Subject: UniStar Nuclear Energy, NRC Docket No. 52-016  
Response to Request for Additional Information for the  
Calvert Cliffs Nuclear Power Plant, Unit 3,  
RAI 265, Groundwater

**Response to NRC Request for Additional Information  
RAI 265, Question 02.04.12-13, Groundwater,  
Calvert Cliffs Nuclear Power Plant, Unit 3**

**Question 02.04.12-13**

Figure 1 - Conceptual Configuration of Waterproofing Membrane

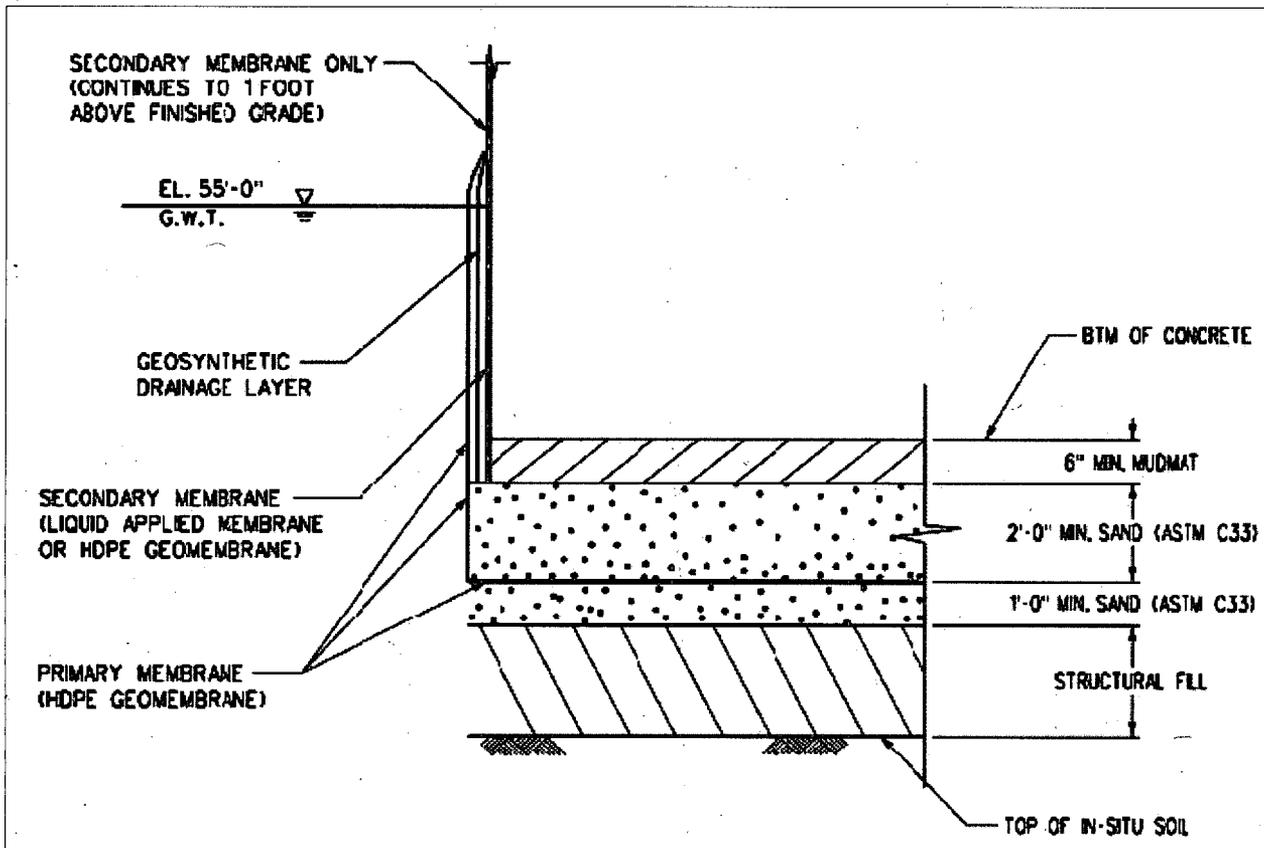
1. In response to RAI 101, Question 02.04.12-11, the Applicant provided a Groundwater Model Study report and associated model input files for a multi-layer groundwater flow model used to assess post-construction groundwater elevations, transport pathways, and radionuclide transport (in COL FSAR 2.4.13). The model provides a detailed representation of the excavation and building foundations of CCNPP Unit 3, but does not represent the use of lean concrete as a fill material. As described in COL FSAR Section 2.5.4.5, Rev. 6, excavation in the power block area is to the Stratum IIb Chesapeake Cemented Sand and "excavations are backfilled with compacted structural fill to the foundation level of structures or lean concrete is placed as a leveling mat," (FSAR pg 2-1241). As noted at COL FSAR pg. 2-1261, "Lean concrete, in lieu of compacted structural fill, with a minimum unconfined compressive strength of 2,000 psi is used under the Common Basemat," which supports the reactor, fuel, and safeguards buildings (as shown in COL FSAR Figure 2.5-104). The emplacement of the lean concrete is shown in the excavation profiles of COL FSAR Figures 2.5-130 to 2.5-134. Provide a revised analysis of groundwater flow that includes the use of lean concrete in the excavation or the technical basis for omitting the lean concrete from the groundwater flow analysis.

2. In response to RAI 144, Question 03.08.04-4, the Applicant provided a description of the waterproofing system to be used to protect concrete foundations. Provide the technical basis for omitting the waterproofing materials from the groundwater flow analysis.

The lean concrete in question refers to concrete mud mats approximately 6 to 12 inches thick emplaced below the foundation subgrades (Figure 1). Mud mats provide a clean and level working surface and prevent the subgrade soil from being disturbed due to precipitation and rutting from construction traffic. The mud mats will underlie the concrete foundations and will not extend laterally beyond the outer perimeter of the foundations (UniStar, 2010). Therefore, in the post-construction groundwater environment, the thin low permeability mud mats below the base of the reactor, fuel, and safeguards buildings foundations will have little to no effect on the post-construction groundwater elevation, flow velocity, gradients, or flow direction.

As indicated in the response to RAI 144, Question 03.08.04-4<sup>1</sup>, the waterproofing system for the nuclear island common basemat consists of two layers (Figure 1). The inner layer is a liquid-applied or high density polyethylene (HDPE) sheet waterproofing membrane layer applied to the embedded concrete walls from about one foot above the finished grade to the bottom of the wall. A vertical drainage geonet layer is then attached to the wall. The second layer, a HDPE geomembrane covers the drainage geonet and forms the primary waterproofing membrane layer.

As indicated in the response to Part 1 above, the mud mat, and therefore the primary HDPE geomembrane below the mud mat does not extend laterally beyond the outer perimeter of the foundations. Therefore the enveloping impermeable HDPE geomembrane will have no effect on the post-construction groundwater elevation, flow velocity, gradients, or flow direction, and it was not included as a feature in the post-construction groundwater flow analysis.
